CABLE TERMINATIONS

BSURE TERMINAL AND TRANSMISSION UNITS

DESIGN REVIEW TEAM REPORT

COMPILED BY CHESAPEAKE DIVISION,

Figure 3. Redesigned Cable Termination Cross Section

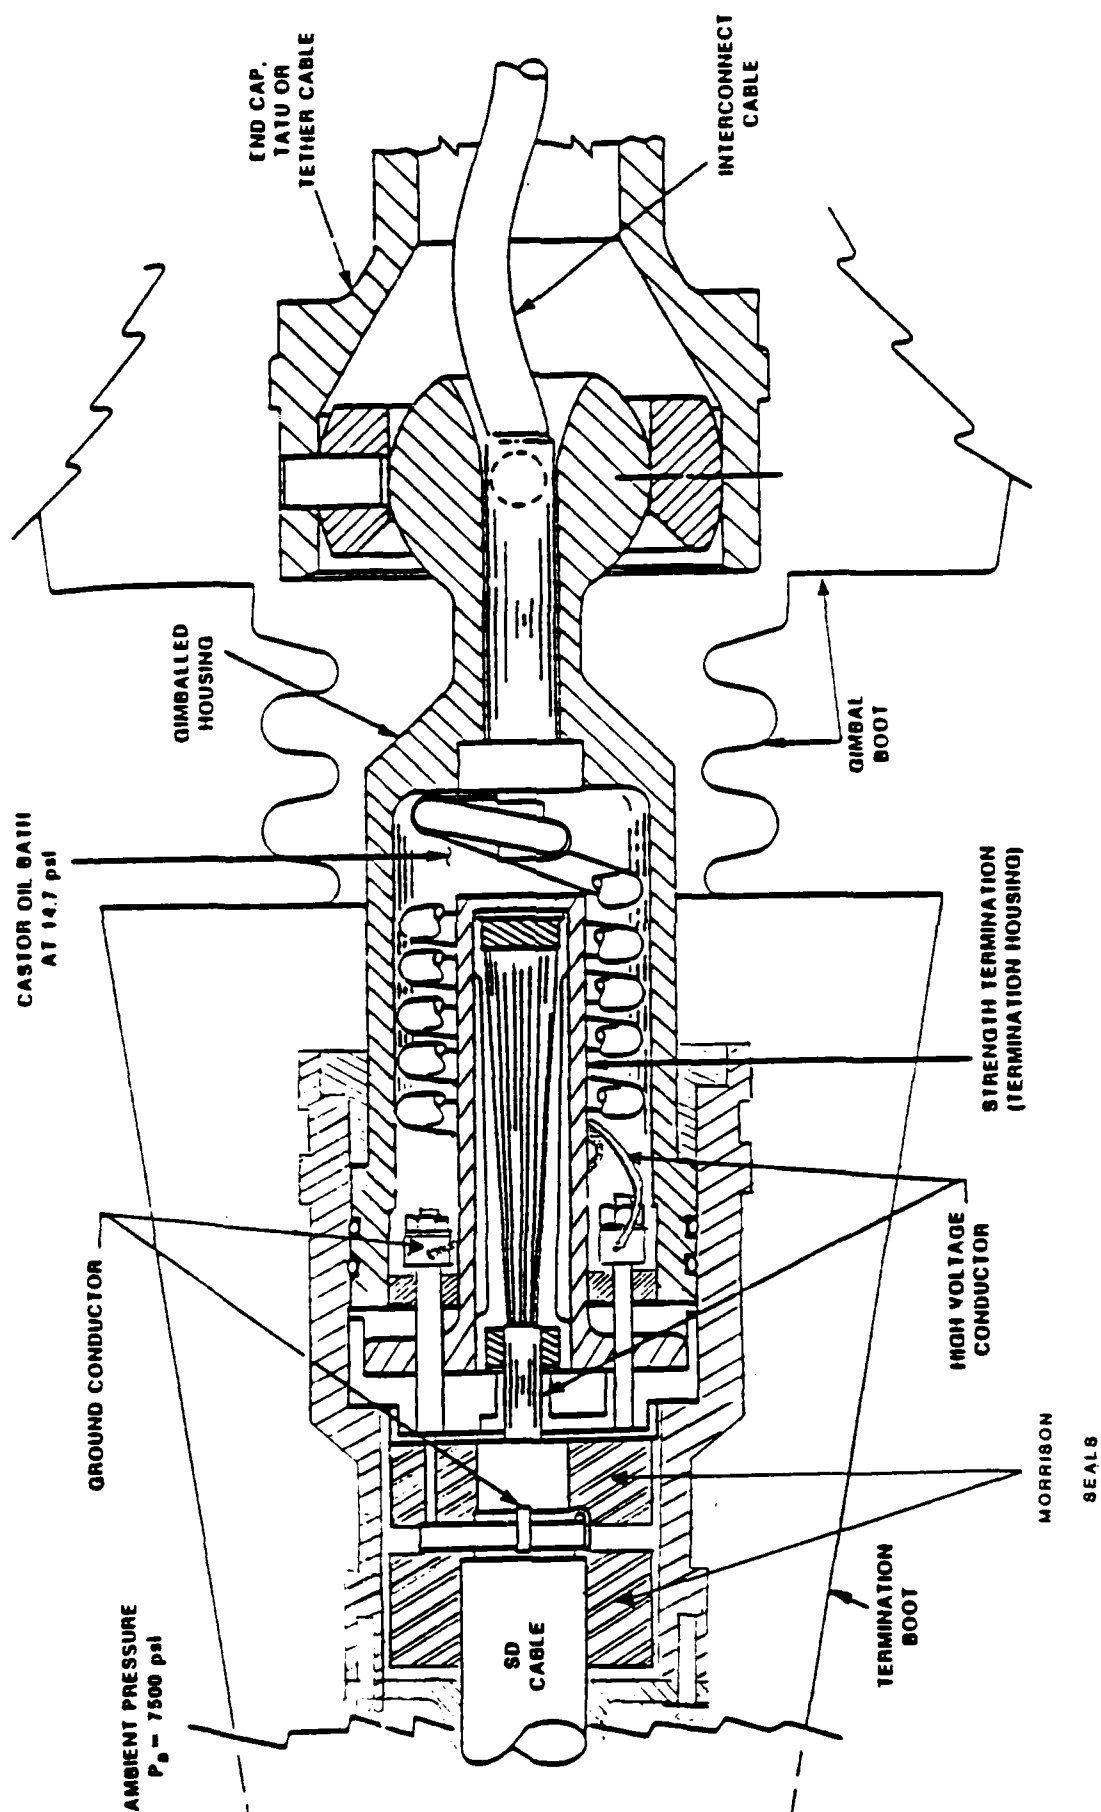
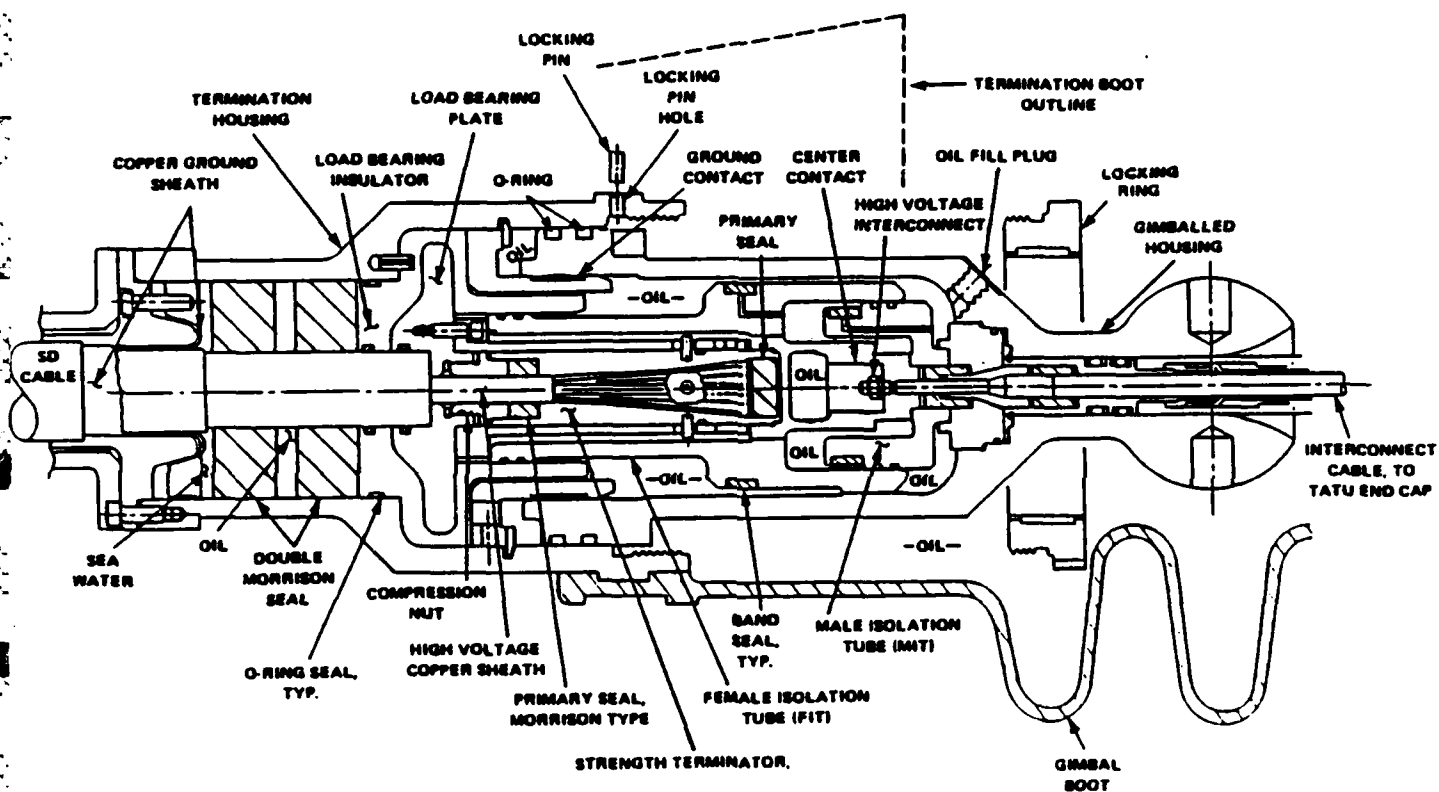
In the original design, the copper ground sheath was attached to an off-center pin connected to the coiled cable assembly through a Morrison seal. A leak path developed through this seal as a result of torque experienced by the termination. The torque caused relative rotation between the termination housing and the Morrison seal which in turn caused the pin to move inside the seal. A cable outer jacket leak eventually caused the seal to develop a leak along its interface with the pin which culminated in failure of the termination. In the redesign, the eccentric pin has been eliminated by removing the outer insulating jacket of the SD cable where it enters the termination unit. The copper ground sheath has been folded back and clamped to the metal housing of the TATU to assure reliable grounding of the ground sheath without off-center penetration of the seal.

TAPER NUT, PC. #27

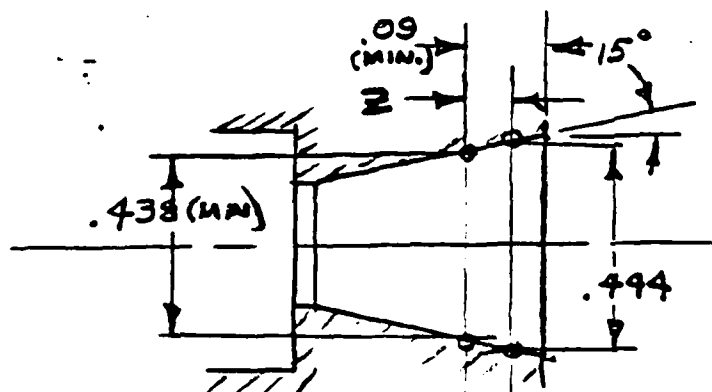
$$\begin{array}{r} .497 \\ - .444 \\ \hline .053 \\ \times 2 \\ \hline .106 \\ - .0265 \\ \hline .0265 \end{array}$$

$$X = \frac{.0265}{\tan 15^\circ} = .0989$$

$$Y = 1.06 - .63 - .0989 = .3311$$

SEAL (20) 7563620

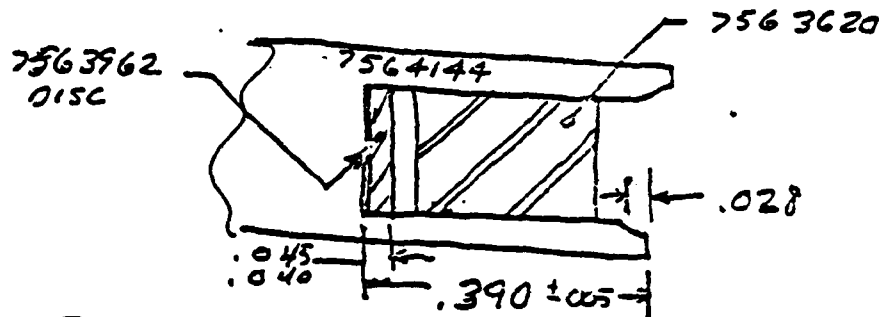
$$\frac{.13028}{.7854 \times (.685)^2} = \frac{.13028}{.3685} = .3535$$

$$.385 - .045 - .028 = .312$$

$$\begin{array}{r} .3535 \\ .312 \\ \hline \end{array} \rightarrow .0415 \text{ INTERFERENCE}$$

1. CHANGE TERMINATOR, DELCO DWG 7564144, AS FOLLOWS TO PROVIDE
MORE SPACE FOR SEAL (20)
